DATE: June 10, 2014
TO: Sean Sullivan, JS Sullivan Development, LLC
FROM: Joy Navarrete, Planning Department
RE: PPA Case No. 2014.0562U for 469 Eddy Street

Preliminary Project Assessment

Date: June 10, 2014
Case No.: 2014.0562U
Project Address: 469 Eddy Street
Block/Lot: 0337/014A
Zoning: RC-4 (Residential – Commercial, High Density) Use District
North of Market Residential Special Use District
80-T Height and Bulk District
Area Plan: None
Project Sponsor: Sean Sullivan, JS Sullivan Development, LLC
415-206-1758
Staff Contact: Kansai Uchida – 415-575-9048
kansai.uchida@sfgov.org

This plan diagram should help clarify the intent.

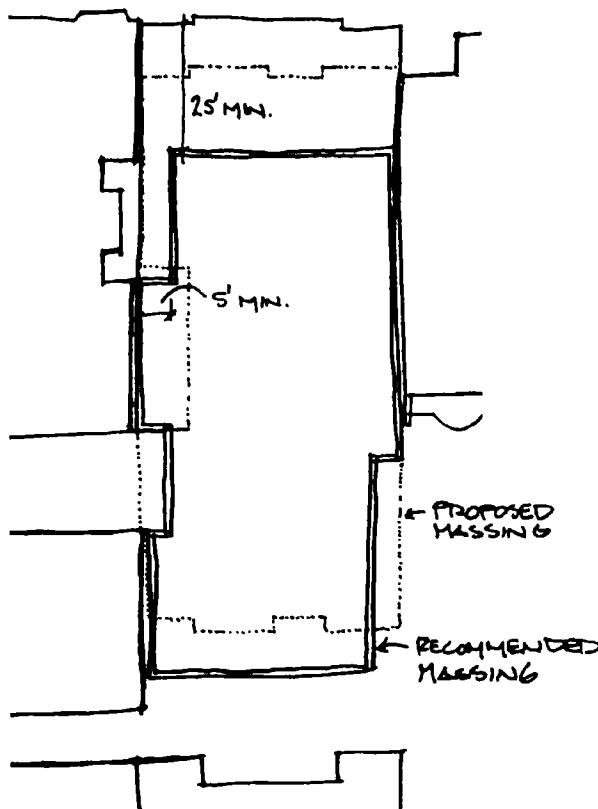
1. **Site Design, Open Space, and Massing.** The Planning Department recommends adjusting the massing of the project 1) to create a better relationship between it and the existing building as well as other buildings on the street frontage, and 2) to better respond to and accommodate the relationships between the building massing and open spaces at the rear, light well, and setbacks

The Planning Department recommends better integrating and preserving the existing historic resource to be more fundamentally a part of the project by setting the addition back a minimum 25'. The interior of the new structure should appropriately reuse or relate to the retained portion of the existing resource.

Re-configure the plan to minimize units that do not meet the exposure requirements.

Match the adjacent light well on the west side of the property to bring the west side of the property in a minimum of 5' to match the adjacent lightwell.

Additionally, the project should create a lightwell or notch at the back open notch of the westside property and could also create a reciprocal notch at the open space to the east. The Planning Department would support the rear wall moving back as long as exposure requirements are met either there or with the adjacent open space on the east side.

Title: 469 Eddy Street - PPA Shadow Fan
 Comments: 2014.0562U
 0337/014A
 Printed: 30 April, 2014

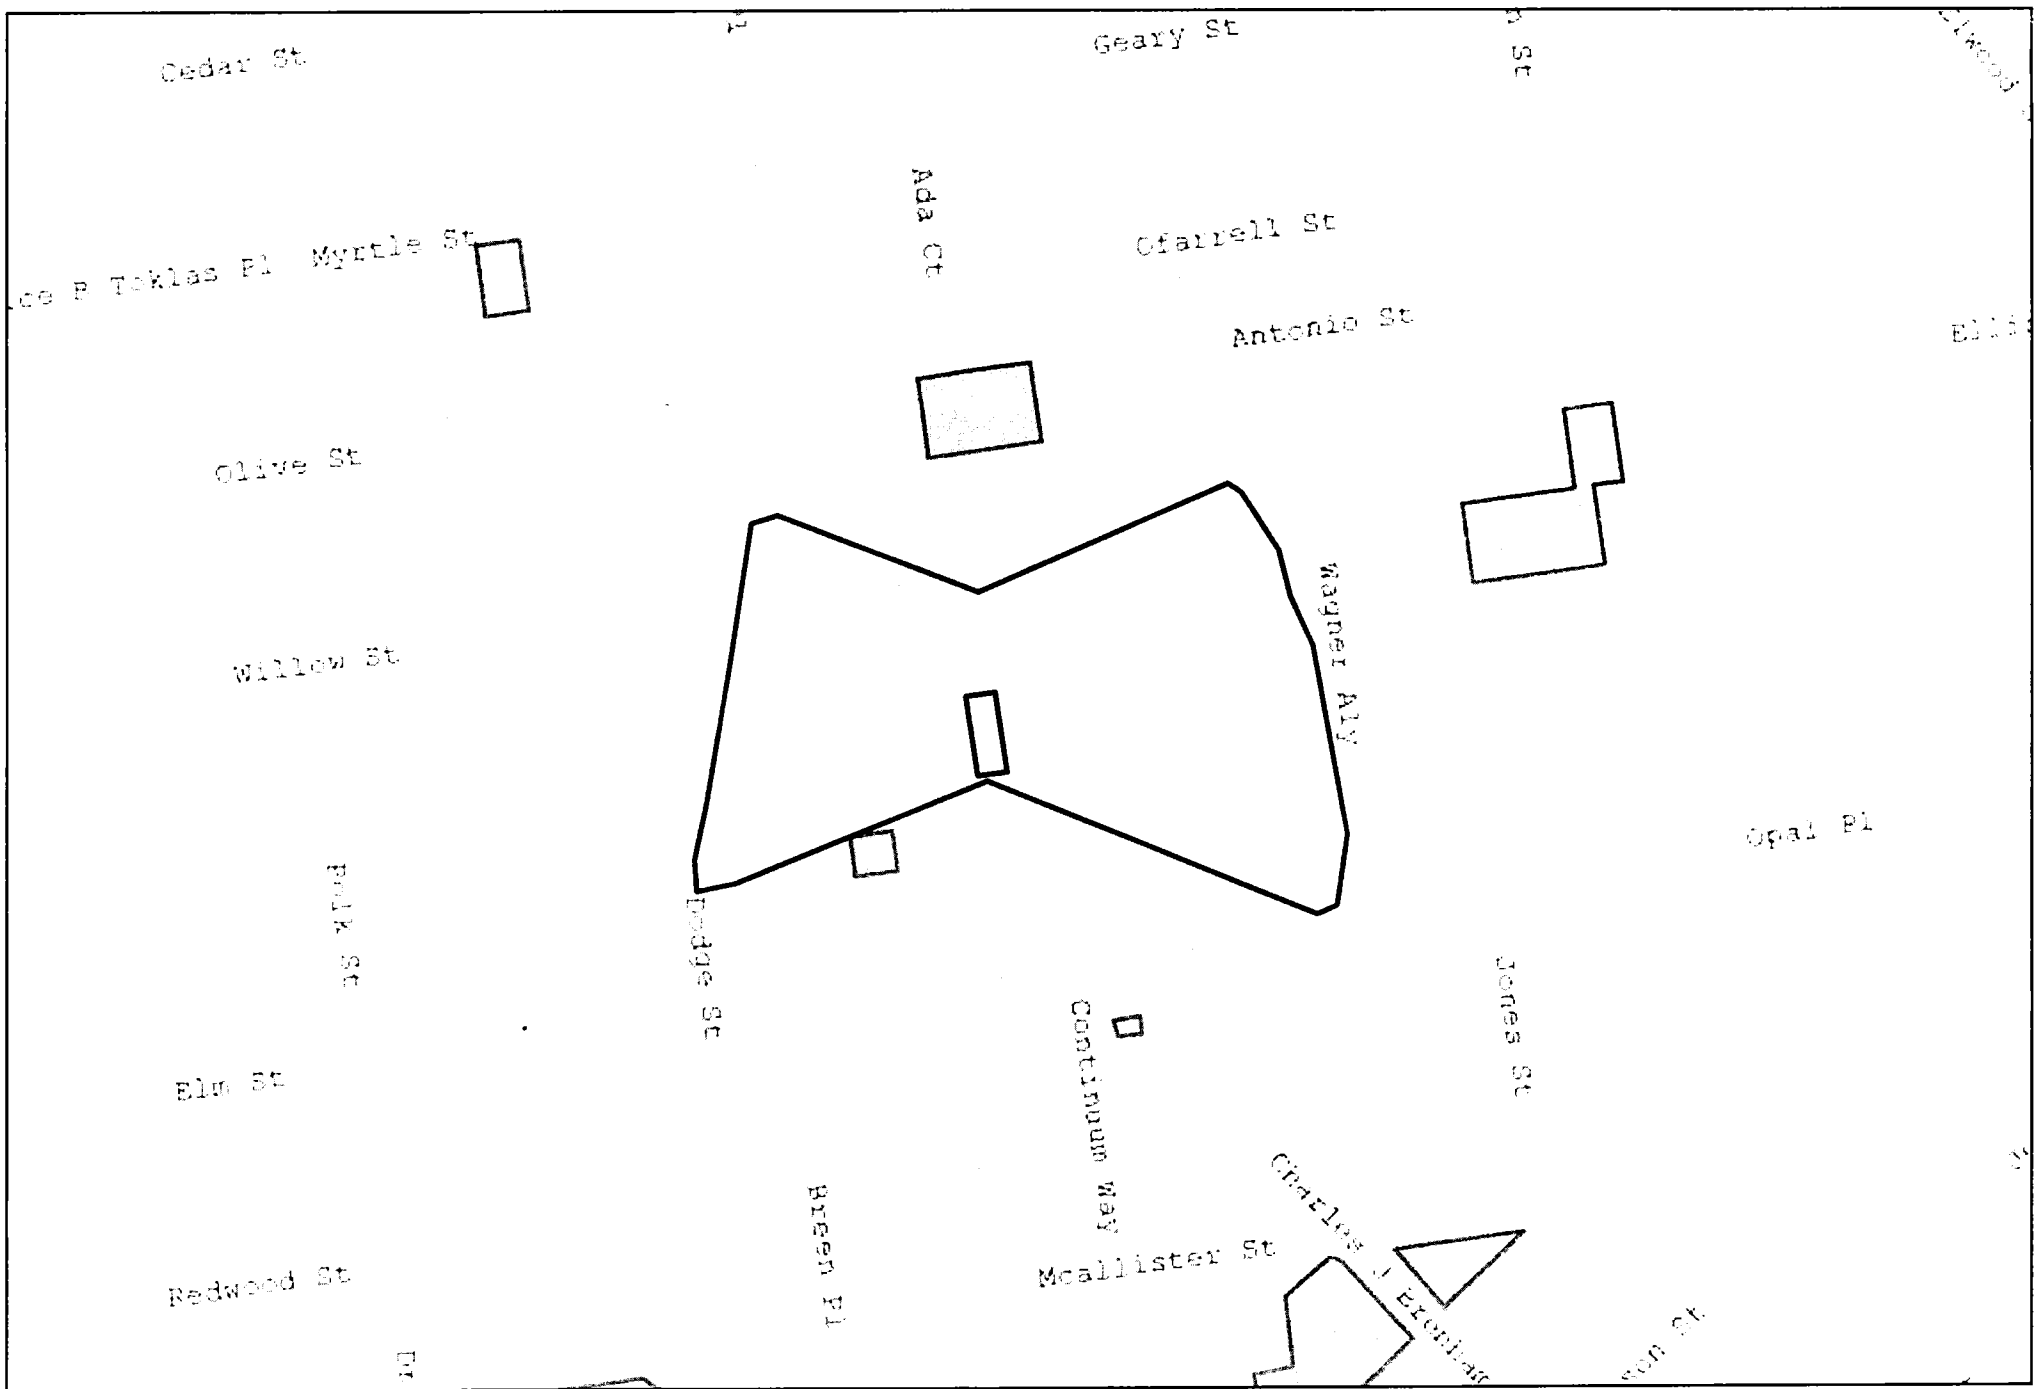
- Show the number of Class 2 bicycle parking required by code.
 - Consider moving all bike parking to ground level.
6. **Shadow Study.** The proposed project would result in construction of a building 40 feet or greater in height. Staff has prepared a preliminary shadow fan analysis that indicates potential shadow impacts from the project to the northern portion of the Turk and Hyde Mini Park (see the enclosed PPA Shadow Analysis). The project therefore would require a shadow study. The project sponsor would be required to hire a qualified consultant to prepare a detailed shadow study. The consultant would be required to prepare a proposed scope of work for review and approval by the Environmental Planning case manager prior to preparing the analysis.

3. A **Shadow Study Application** per Planning Code Section 295 is required for the project, as the proposed building exceeds 40 feet in height. Staff has prepared a preliminary shadow fan analysis that indicates potential shadow impacts from the project to the northern portion of the Turk and Hyde Mini Park (see the enclosed PPA Shadow Analysis). However, this shadow fan does not account for the presence of intervening buildings. The location of the project in relation to intervening buildings would suggest that any potential shadow on the Turk and Hyde Mini Park would be blocked by intervening buildings, or subsumed by shadows cast by other buildings in the area. To determine the extent of potential shadow impacts, a detailed shadow analysis would need to be prepared to determine if the project would create new shadow that results in an adverse impact to the Turk and Hyde Mini Park, pursuant to Section 295. If the project would create new shadow in a manner that substantially affects property under the jurisdiction of the Recreation and Parks Commission, a joint hearing between the Recreation and Parks Commission and Planning Commission would be required.
